Working Party on Inland Water Transport

Working Party on the Standardization of Technical and Safety Requirements in Inland Navigation

I. Proposal by the delegation of the Netherlands in document ECE/TRANS/SC.3/WP.3/2010/11/ADD.1

Additional information

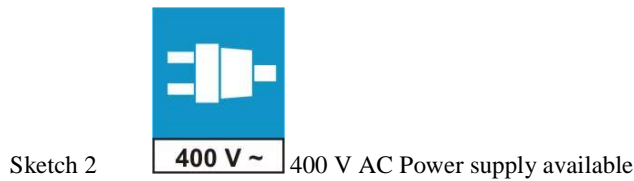
4. The sign to be added is an informative sign, hence, the proposed number is E.25. (sketch 1 below). However, this sign can be supplemented with an auxiliary sign indicating the type of voltage available (as shown in sketch 2 below).

5. Chapter 5.2.4. of SIGNI deals with panels giving explanations or additional information to signs. So far, there is no description of an informative sign bearing an auxiliary sign in this chapter. All the signs in 5.2.4. are of the prohibitory or mandatory types. It is proposed, therefore, to add an example of an informative sign with a panel giving explanations or additional information (see sketch 2 below).

E.25 Electrical power supply available

400 V AC Power supply available
